SUBJECT: Arkansas Nuclear One - Unit 1
Docket No. 50-313
License No. DPR-51
Arkansas Nuclear One, Unit 1 (ANO-1) Fifteenth
Year Reactor Building Tendon Surveillance Report

AP&L RESPONSE TO NRC QUESTIONS REGARDING ANO-1
FIFTEENTH YEAR REACTOR BUILDING TENDON SURVEILLANCE REPORT

EVALUATION IN RESPONSE TO US NRC COMMENT
REGARDING HORIZONTAL TENDONS
LIFT-OFF VALUES

FIGURE 1

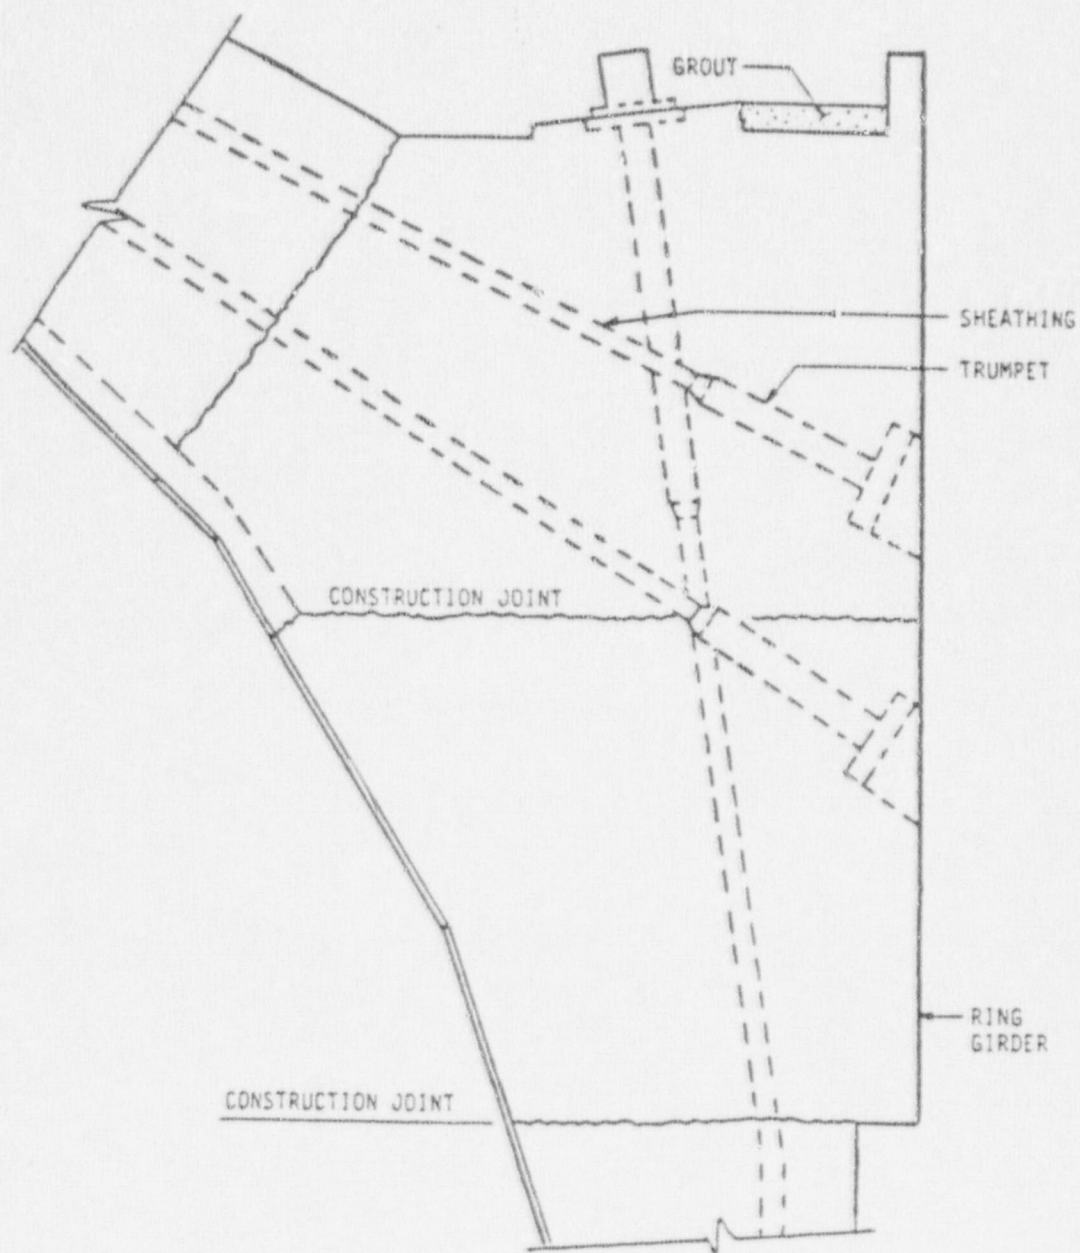
In Section 2 on Table II there are very large differences between the grease removed and the grease added. Explain the reason for such large differences. From the results tabulated it appears that voids may have existed in the tendon sheathing or there may be leakage through the tendon sheathing into the surrounding concrete. In Section 8 the procedure described in Plant Procedure No. 1402.090 Subsection 8.0 appears to be deficient because there is no assurance that the tendon wires are adequately covered by the filler grease. The proper procedure should be: (1) drain the filler material as much as possible from the tendon sheathing, (2) measure the quantity of the collected filler material, and (3) refill the tendon sheathing and record the quantity of the filler material used. The difference between the filler material taken out and put in is a measure of voids in the grease filled space or leakage into concrete. It is to be noted that the procedure described in Section 7 and shown in the figure in Subsections 8.1.6 to determine the correct level of filler material (e.g., on Page D68 of 292), is inadequate as a means to detect tendon grease void for vertical tendons. It was not used for hoop (e.g., on Page D191 of 292) and dome (e.g., on Page D118 on 292) tendons as indicated because of the impracticality of the procedure. However, there is no equivalent procedure for the inspection of tendon grease voids for hoop and dome tendons. In view of the above, please discuss how you plan to change your procedures with respect to tendon grease surveillance.

The dome and vertical tendons cross each other in a configuration shown in figure 1. From this configuration it can be seen that the joint between the trumpet and sheathing for the dome tendon and the vertical tendon coincide at approximately the same location where the tendons intersect each others. Also it happened that a construction joint was located at this intersection. Since the trumpet-sheathing joints are located at the construction joint, it is possible that they had been

disturbed by the construction workers during concrete placement and a path from the dome tendon to the vertical tendon through the concrete may have occurred.

If a path had occurred between the dome and vertical tendons at the intersection as described above, the filler material in the dome tendon could have been drained, undetected, along with the filler material from the vertical tendon. When the vertical tendon was later refilled with the filler material, the filler material could have flowed back into the dome tendon through the interconnecting path between the dome and vertical tendons. In this process, the dome tendon could have only partially been refilled near its end.

In summary, the indicated voids in the tendon sheathing ducts are within the expected, except for dome tendon 3D120. Two postulated reasons for the void in this tendon were given. One related to the initial installation and the second due to possible interconnection between the dome tendon duct and a vertical tendon duct. From the collected information and the fifteenth year surveillance report the following could be concluded:

FIGURE 1 - TENDONS SURVEYED MORE THAN ONE TIME

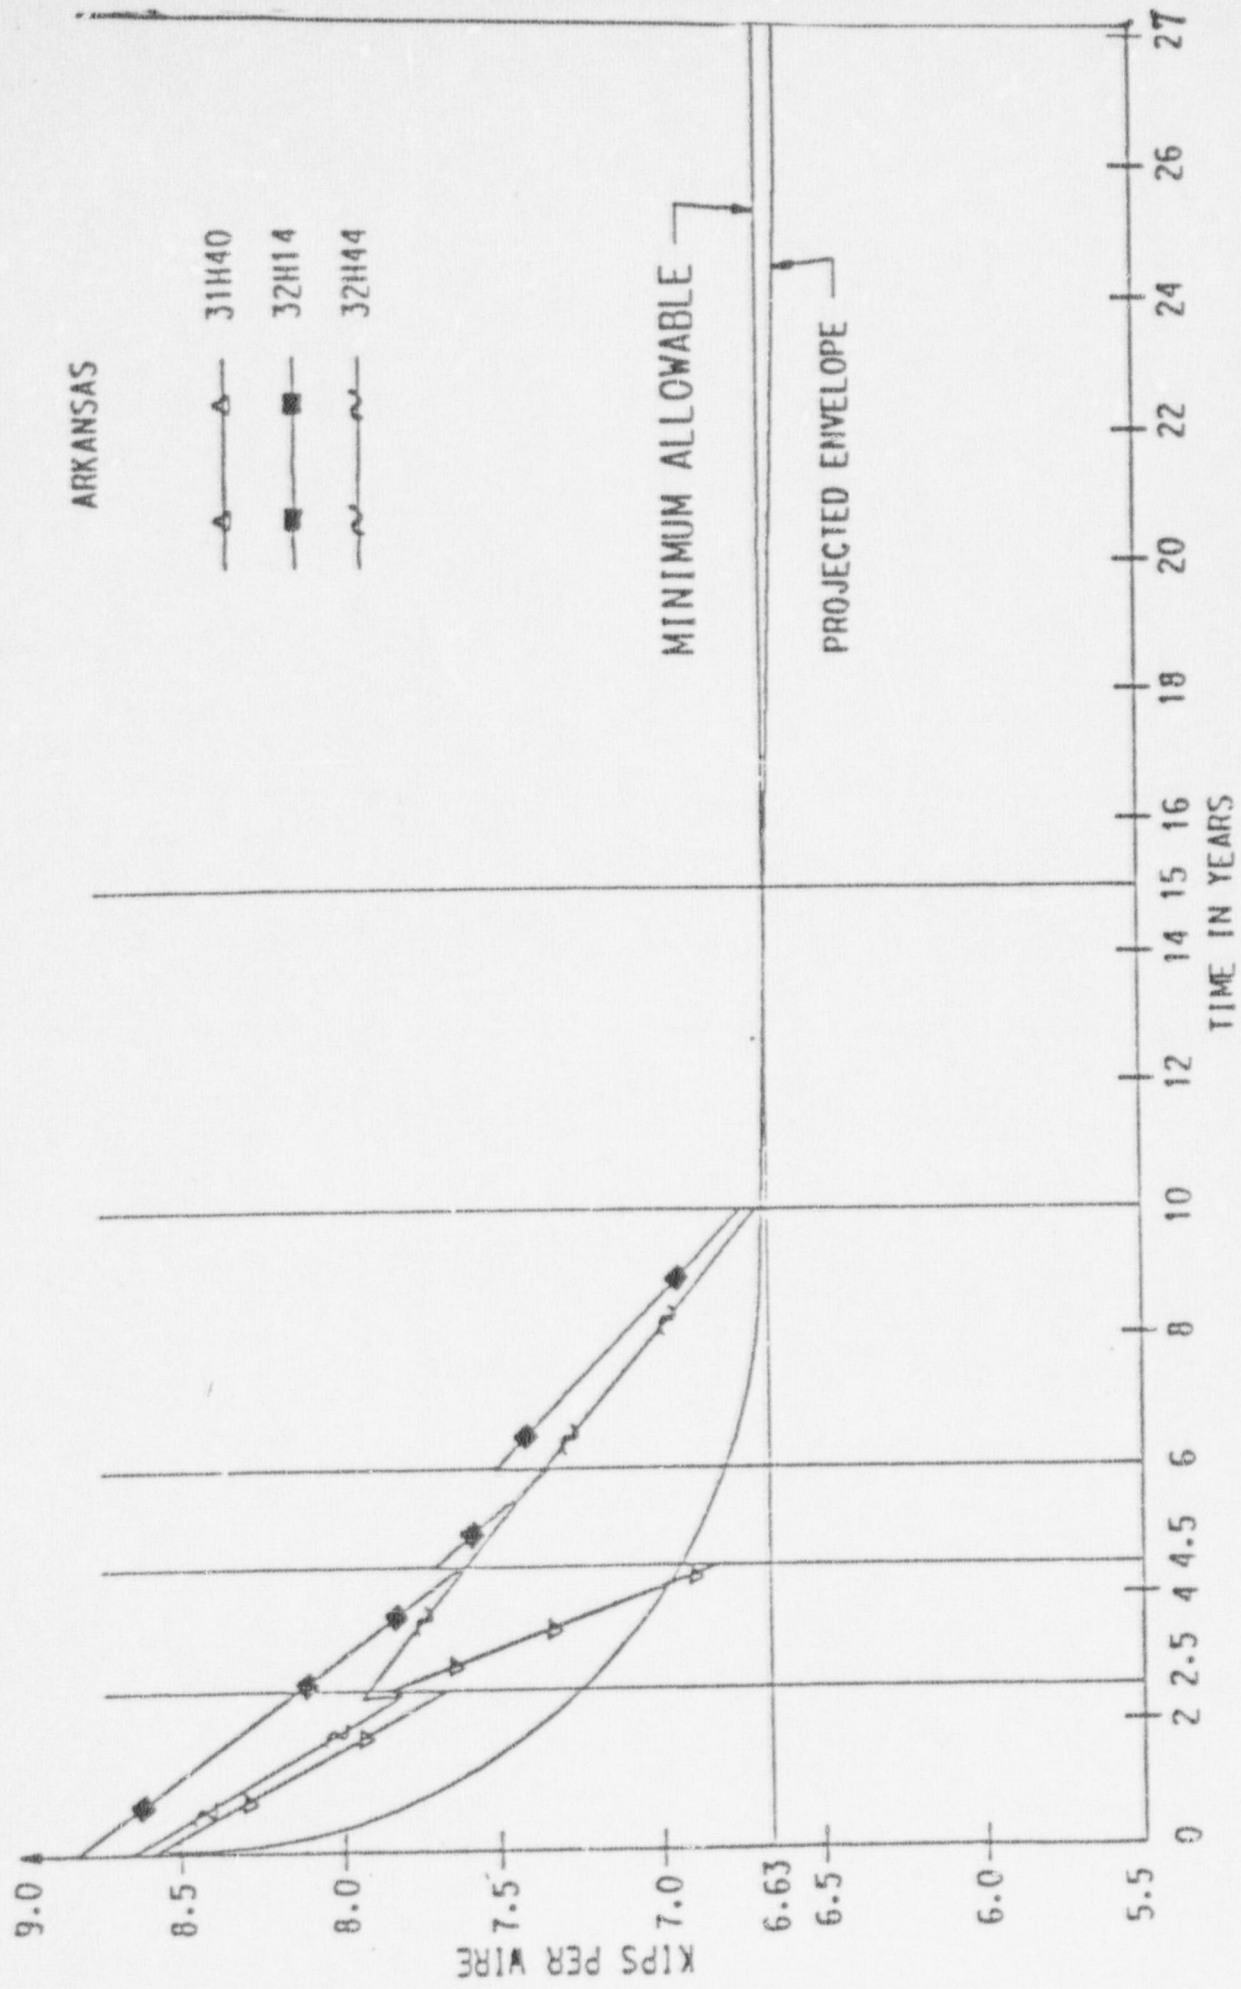
In examining Figures 4, 5 and 6 in Section 2 of the report, one can discern the trend of the tendon forces on the basis of the same tendons inspected. For instance, for vertical tendon No. V40, by joining the tendon forces for the first and second surveillances with a straight line and extending the line to forty years, the tendon force is found to be above the minimum required tendon force. However, for hoop tendons Nos. 21 H42, 31H40, 32 H14, and 32 H44, if the same process is repeated, the forces in these tendons reach the minimum required at ages of less than 13 years. It appears that because of the low tendon force in tendon 31 H40 discovered in the second surveillance, adjacent tendons 31H39 and 31H41 were detensioned in the second surveillance. Unfortunately, as these tendons were not detensioned in the subsequent surveillances, no conclusion can be drawn on the trend of these tendons. However, from the trends of the four similar hoop tendons inspected in two or three surveillances, the losses of tendon forces appear to be much more than expected and the tendon forces will be below the minimum required before the forth year life is reached. For dome tendon No. 1D20 the trend appears to be that the tendon force will be above the minimum required force. In view of the above observations discuss how you will modify the tendon surveillance procedure so as to ensure that the tendons inspected are truly representative of the tendon group as a whole and not only meet the tendon force requirements at the time of surveillances but also indicate a trend that the tendon forces will not fall below the tendon force requirements before subsequent surveillances. Also discuss the causes of tendon force losses which were larger than expected.

During the first four surveillance programs, five horizontal tendons (21H42, 31H40, 32H14, 32H44 and 32H40) were surveyed more than one time each. Later lift-off readings of these tendons exhibited increased losses beyond those experienced by other tendons which were surveyed only one time. Direct connection of two consecutive lift-off readings, of any of these tendons, show that the extension of the connecting lines intersects the minimum design requirement line before the end of the service design life of the system. However, tendons that were surveyed more than one time and with the second lift-off measurements performed before the third surveillance (early surveillance programs), had connecting lines with a steeper slope than those for the tendons that had their second lift-off measurements after the third year surveillance (late surveillance programs), (see figure 1).
